Mr. Payam Bozorgchami  
California Energy Commission  
Dockets Office, MS-4  
Re: Docket No. 17-BSTD-01  
1516 Ninth Street  
Sacramento, CA 95814-5512

**NEMA Response to Comments on NEMA Standard Publication 77-2017 in Docket 17-BSTD-02**

## NEMA Response to Comments on NEMA Standard Publication 77 in Docket 17-BSTD-02

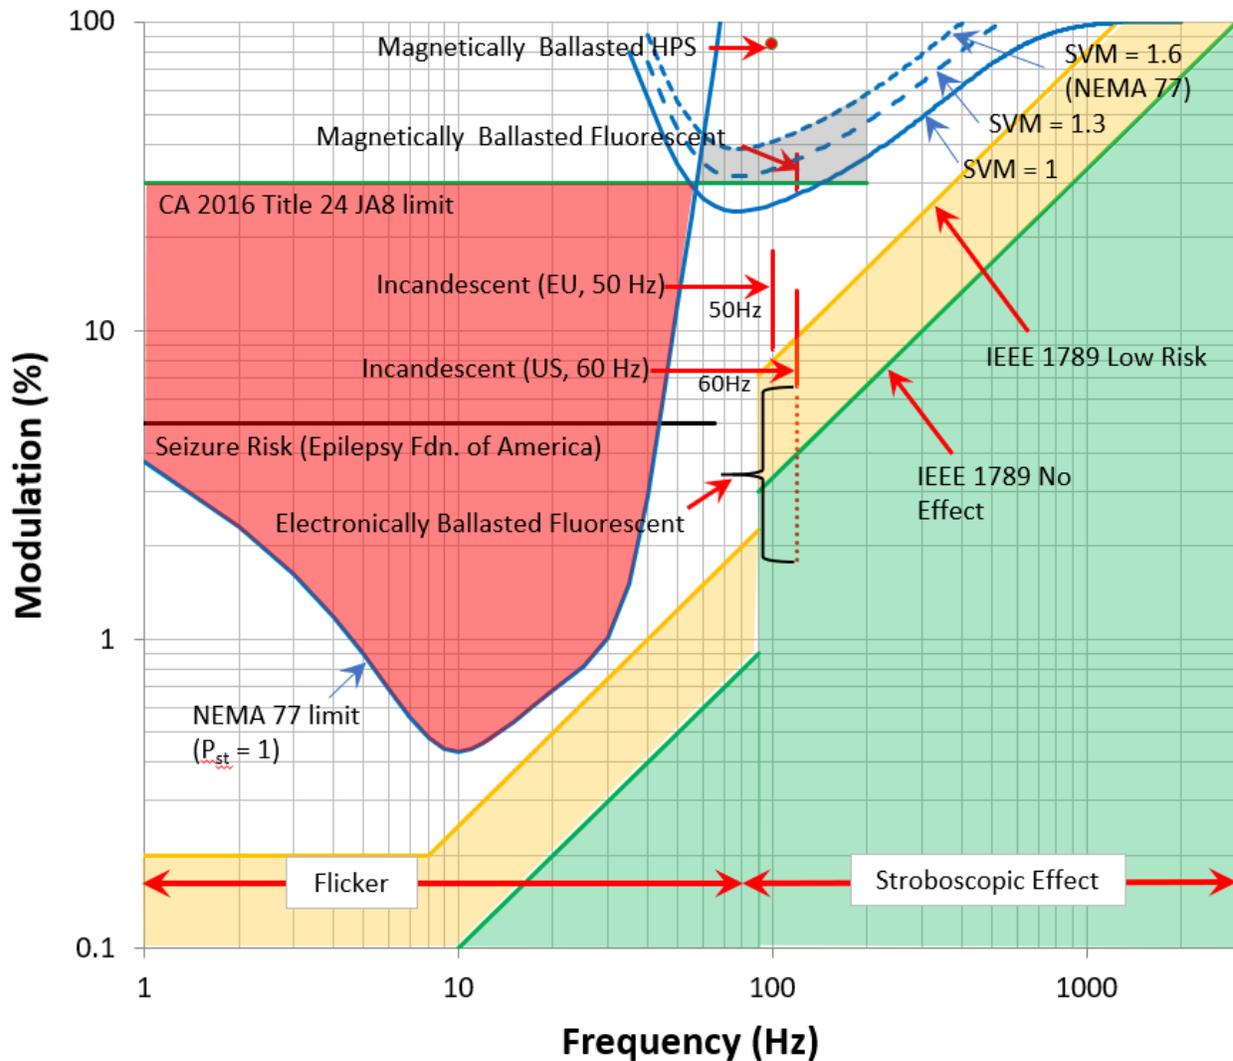
- d. We note the proposed limits of NEMA 77 are much closer to the IEEE 1789 specification than CA Title 24 Joint Appendix JA-10 are. (See Figure below.)

- f. At a visual interference level of 50% (SVM = 1.0) the visual phenomenon of flicker is just barely perceptible if you have been asked to pay attention in highly controlled lab conditions. That is why SVM=1.0 is the appropriate threshold for *observation*. In contrast, Title 24’s present specification allows TLA that is visible to nearly 100% of the population, with or without motion (30% modulation depth below about 50 Hz – see figure below).

- The statement that IEEE 1789 recommends half the flicker value of Title 24 is incorrect. The relationship between the two depends strongly on frequency -- it is a “sliding scale” as clearly shown by the figure below. At some frequencies, IEEE 1789 is more than two orders of magnitude stricter than Title 24. NEMA 77 also recommends levels stricter than roughly half the Title 24 limits over much of the frequency range.

For reference the figure of IEEE 1789 at issue cited in previous NEMA comments is repeated below with an additional shaded area to visually demonstrate the performance area required by NEMA 77. We note the conditions given in the figure for non-LED light sources (in red) are based on measurements done at Pacific Northwest National Labs (PNNL), except for the line for 50 Hz incandescent lamps, which came from Shackle and Erwin.
